**CITY OF WINTER GARDEN  
DEVELOPMENT REVIEW COMMITTEE  
MINUTES  
August 24, 2016**

**Agenda Item #3: Heritage at Plant Street – PUD Zoning**

Plant Street E – 605 and Newell Street E - 290

M.I. Homes of Orlando, LLC

# The Amhurst

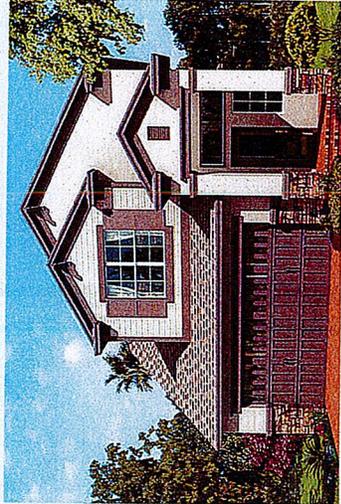
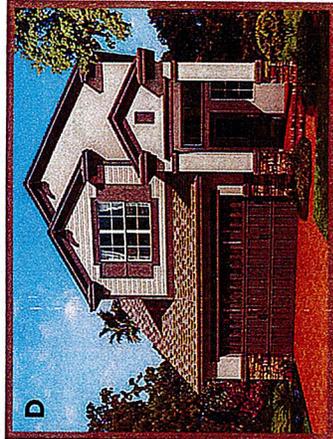
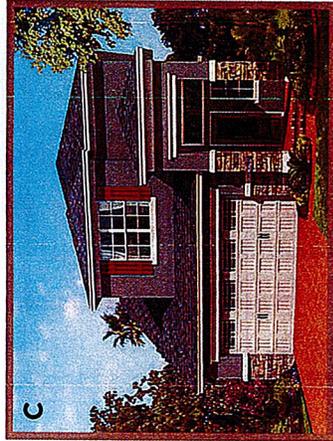
- c. **Four sided color elevations of all homes and townhomes. Only a few single-family models' front elevations were submitted in color.** Applicants provided Exhibit A with various floor plans and exterior design options in the meeting for review by staff.

- b. **In general, Staff believes that the proposed single family residential elevations are too similar- the massing is almost exactly the same. Please provide more architectural variation among units.** Similar response as staff comment 22a.
- c. **City Staff does not support the home models with garages that project beyond the front face of the building. Either the front face of the building or a covered front porch must project a minimum of 5' beyond the front face of the garage. The front setback may be reduced to 15' if a min. 5' deep covered porch is provided. Please revise the elevations and include this information as part of the architectural standards on the plans.** City staff discussed allowances for front porches in the easement but not for garage setbacks. Applicants will review options.
